MFN 06-215 Supplement 1

Docket No. 52-010

Subject: **Response to Portion of NRC Request for Additional Information Letter No. 33 - Containment Systems - RAI Number 6.2-53 S01**

RAI Number 6.2-53 S01

Figure 6.2-53S01-2: DCD TRACG Nodalization of the ESBWR Containment

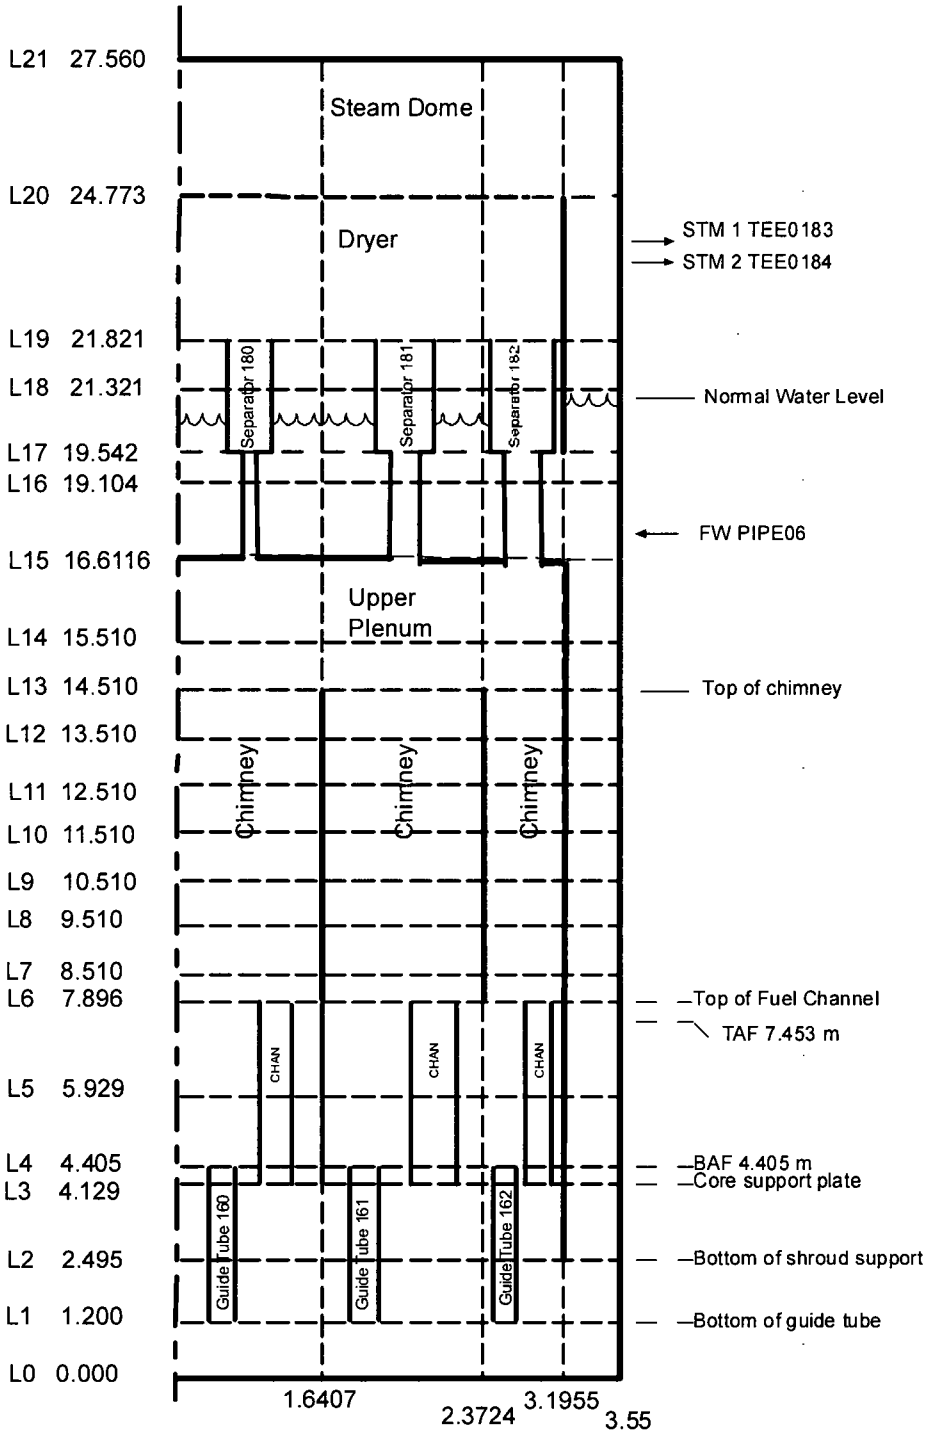
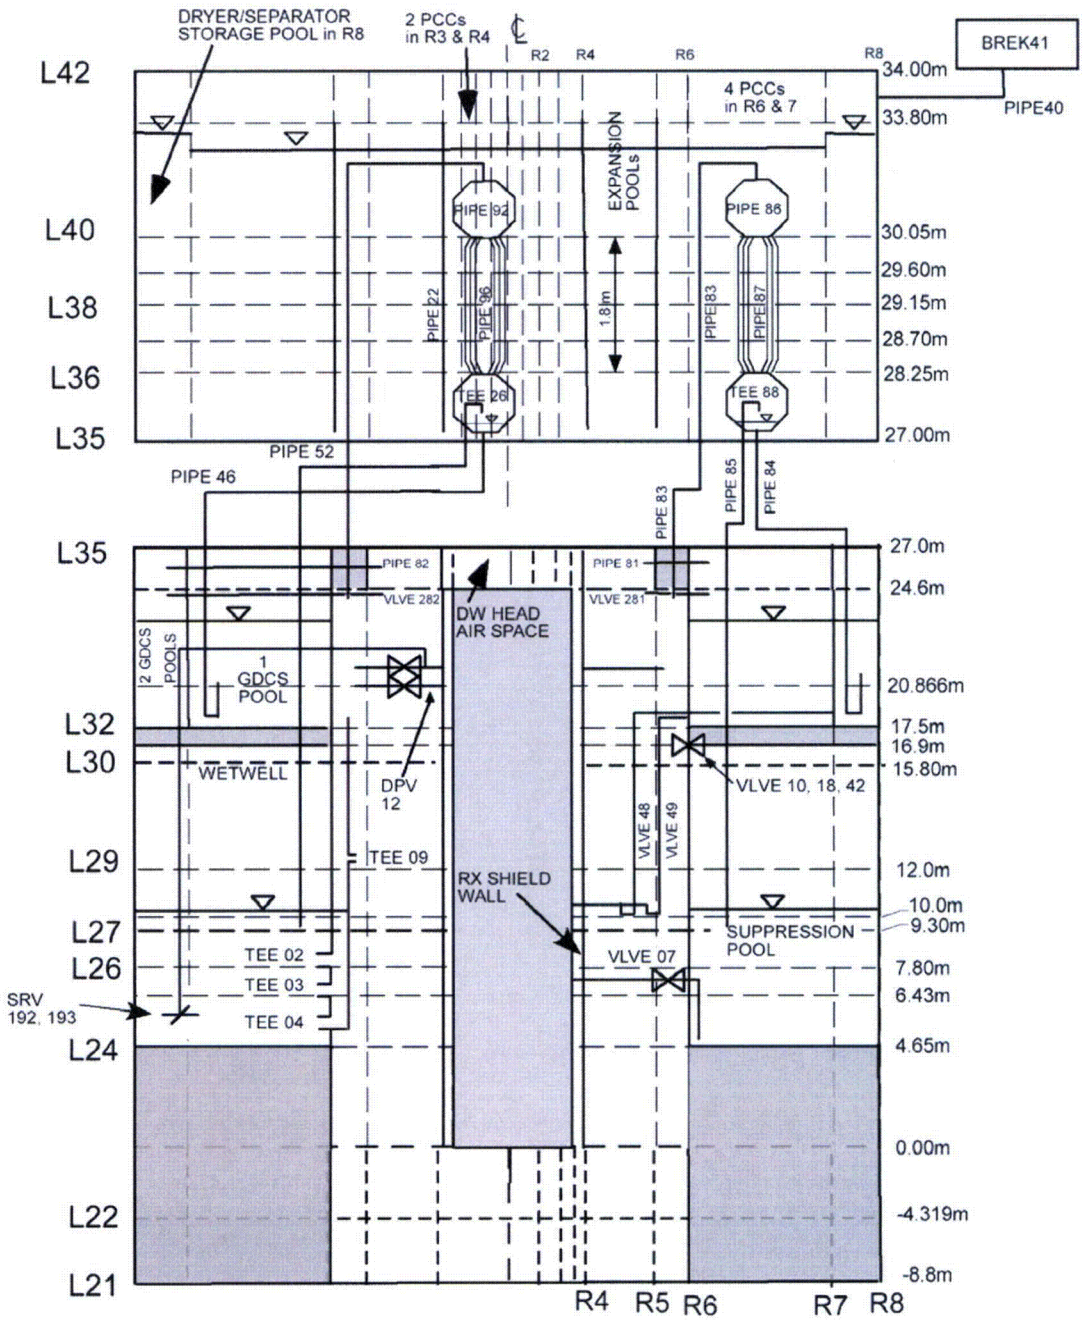
The GENE response to RAI 6.2-53 is for the feedwater line break accident, which was the limiting DBA then. Please update the response as follows:

(2) reflect the modeling changes stated in GENE letter MFN 06-364 in response to RAI 6.2-59, and

In DCD Tier 2, Revision 3, the TRACG nodalization for the containment evaluation was modified to address the earlier comments from the NRC reviewers. The flow path between the Gravity Driven Cooling System (GDCS) air space and the drywell (DW) annulus was changed from 1-pipe connection to 2-pipe connection. This modification was to promote flow circulation and to purge the residual non-condensable (NC) gases in the GDCS pool air space.

Referring to the TRACG nodalization (Figures 6.2-53S01-1 and 6.2-53S01-2), the broken main steam line is located at Level 34 and discharges steam to the DW at this elevation. In

the DCD Tier 2, Revision 2 evaluation, the MSL steam break flow was assumed to discharge at Level 23 (in the DW region below the reactor pressure vessel (RPV) bottom) and to force the NC gases in the DW to transfer into the wetwell (WW). Parametric cases are performed to assess the impact of the discharge location for the steam break flow.

Figure 6.2-53S01-3: Containment Pressure Response (Case A: MSL3_1DPVCB_NL2Pa-72)

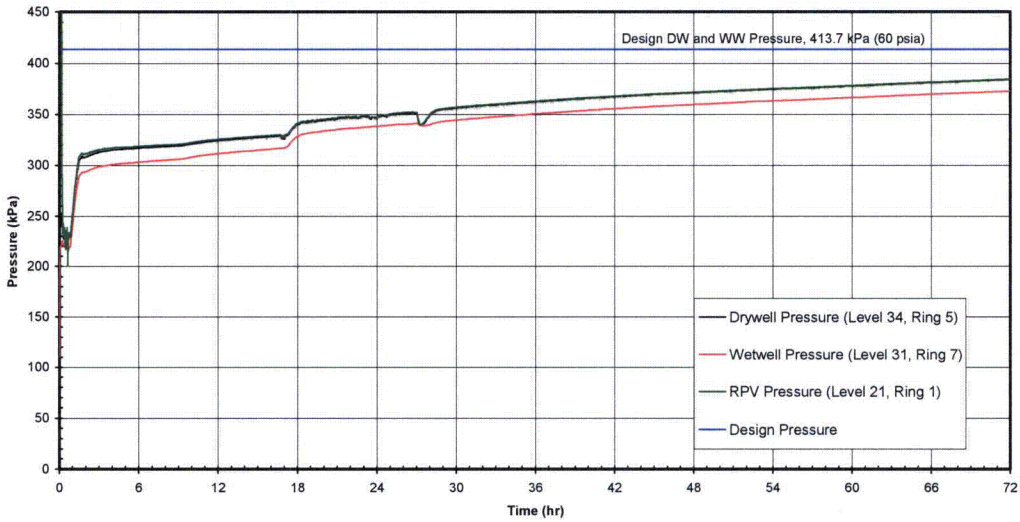
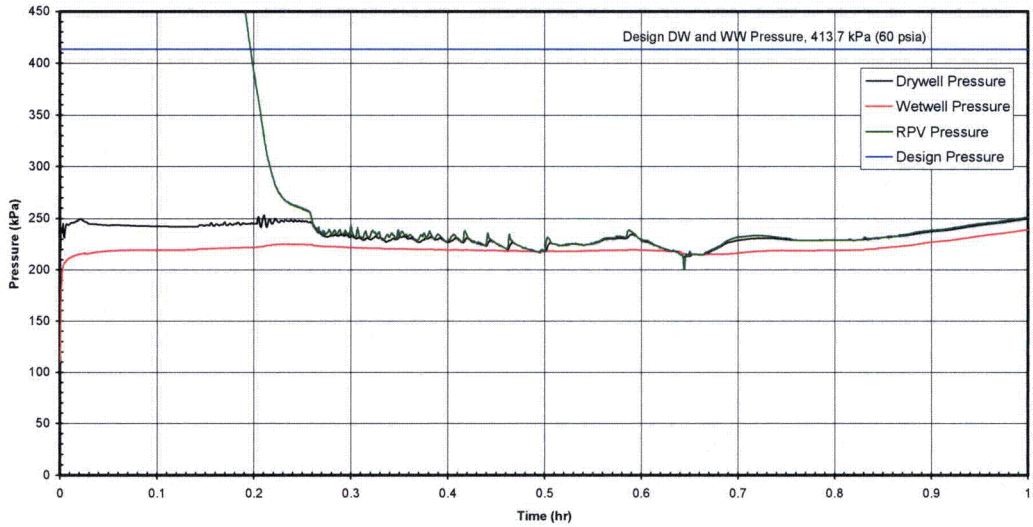
(1) include the current limiting DBA of main steam line break accident,

Figure 6.2-53S01-3 shows the RPV, DW and WW pressures, and Figure 6.2-53S01-3a shows the same responses in short-term time scale.

Following the postulated loss-of-coolant accident (LOCA), the DW pressure increases rapidly leading to the clearing of the Passive Containment Cooling System (PCCS) and main vents. At around 77 seconds, the DW pressure reaches a peak value of 249 kPa (36.1 psia). This peak pressure is below the design pressure of 413.7 kPa (60 psia) with large margin. During this blowdown period, a significant amount of NC gases is purged into the WW and pressurizes the WW. The RPV continues to depressurize due to the break flow and the Automatic Depressurization System (ADS) flows. At around 0.2 hours, the RPV pressure drops below the pressure point at which the GDCS water is allowed to inject into the downcomer by gravity head. The subcooled GDCS water continues flowing into the vessel and reduces the steaming from the RPV and the DW pressure. At around 0.64 hours, the DW pressure drops below the WW pressure, causing the openings of vacuum breakers and allowing some NC gases to flow back into the DW. Consequently, the system pressures drop to a value of about 200 kPa.

Subsequently, the decay heat overcomes the subcooling of the GDCS water and steaming resumes (at ~ 0.67 hours, Figure 6.2-53S01-3a). The resumption of RPV steaming causes the DW pressure to increase again starting from 0.67 hours.

Figure 6.2-53S01-9: DW Annulus NC Gas Pressures (Level 23=2nd Level from Bottom, 34=Top) (Case A: MSL3_1DPVCB_NL2Pa-72)

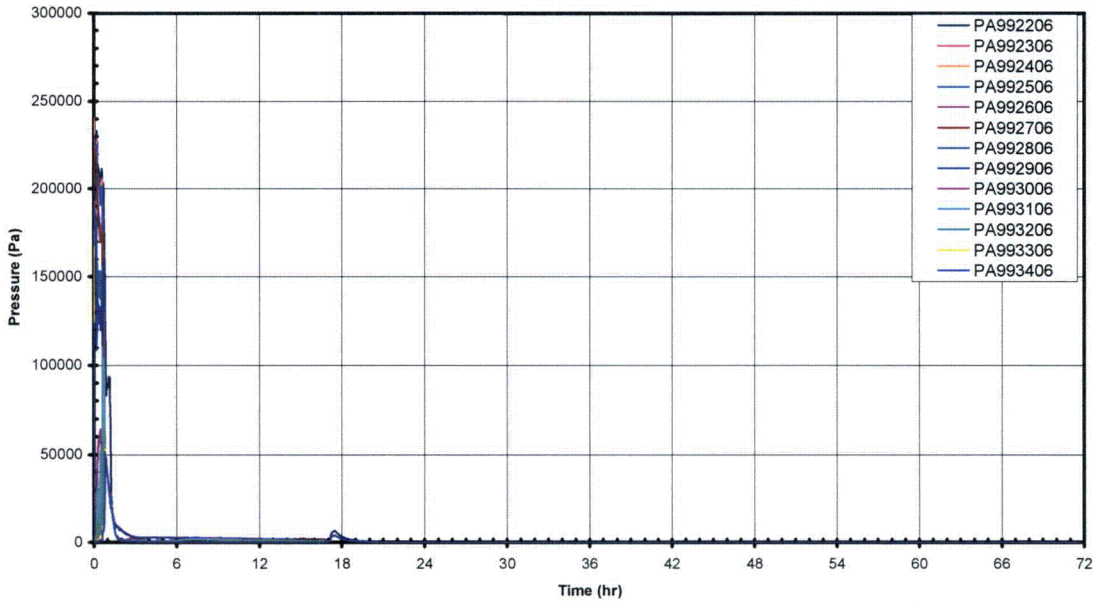
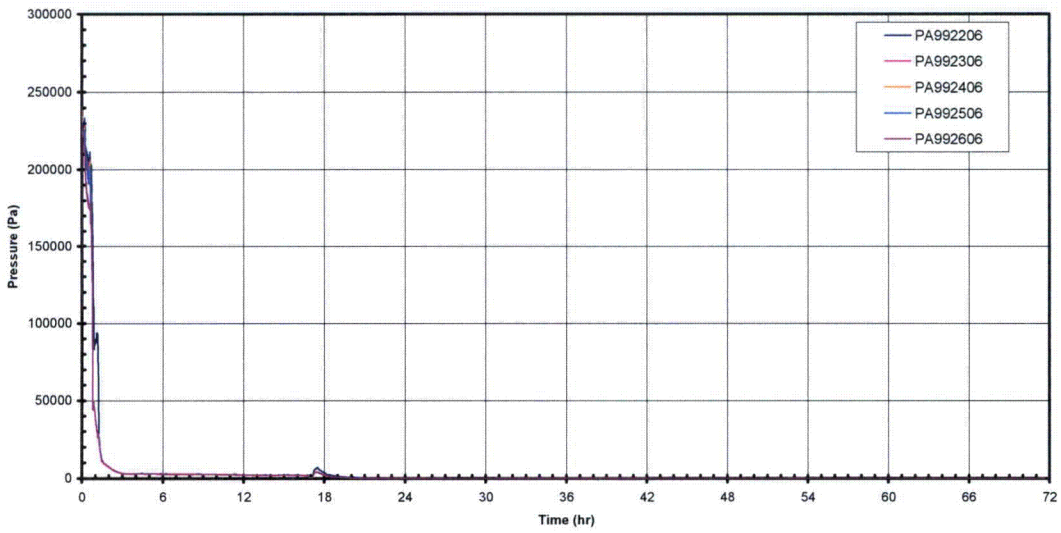
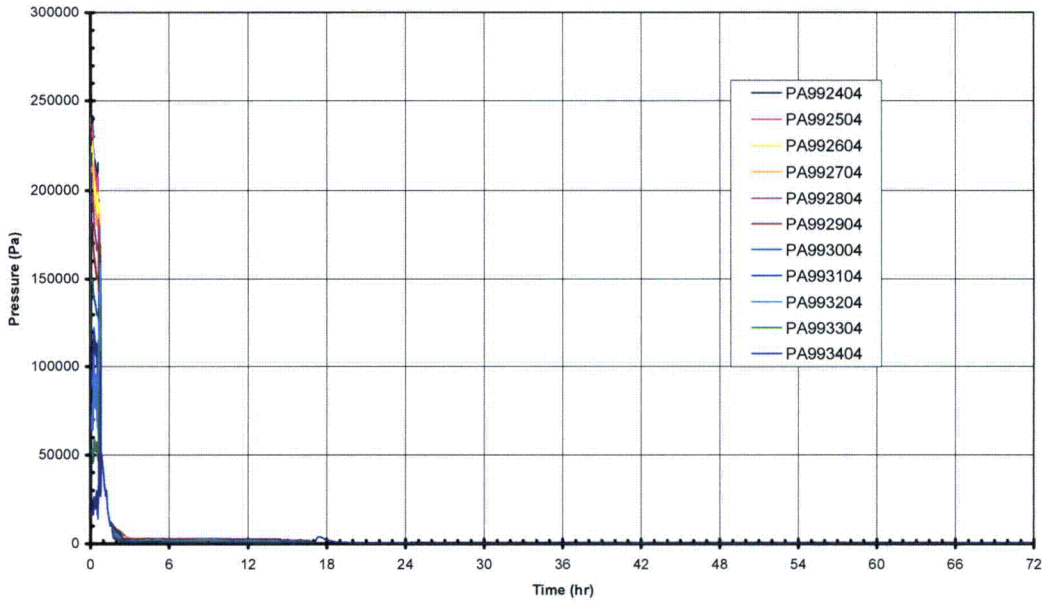
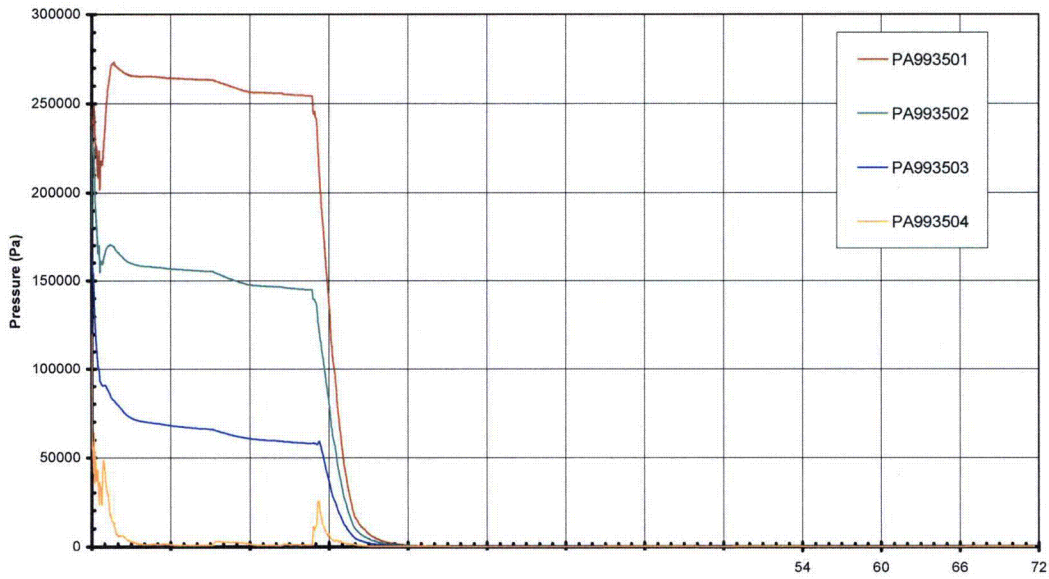
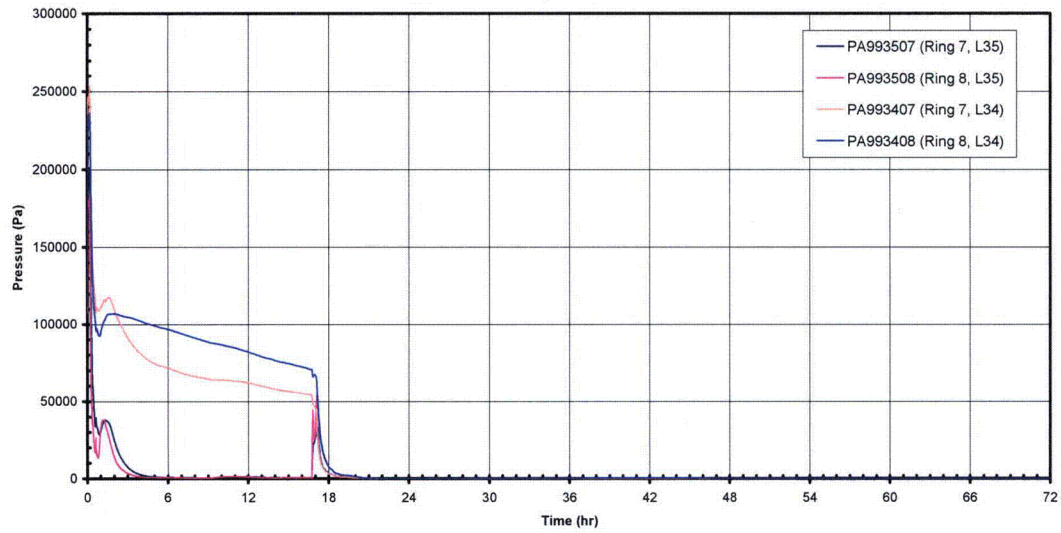
(3) include graphs for non-condensible gas pressure in wetwell versus time.

Figures 6.2-53S01-9 through 6.2-53S01-13 show the NC gases pressures in the DW annulus, lower DW, air gap between the RPV and the reactor shield wall, the DW head airspace, and the GDCS pool airspace. Most of the initial NC gases in the DW annulus are purged into the WW within 3 hours. It takes about 24 hours to purge most of the NC gases in the DW head airspace (Figure 6.2-53S01-12). It takes about 20 hours to purge most of the NC gases in the GDCS pool airspaces (Figure 6.2-53S01-13).
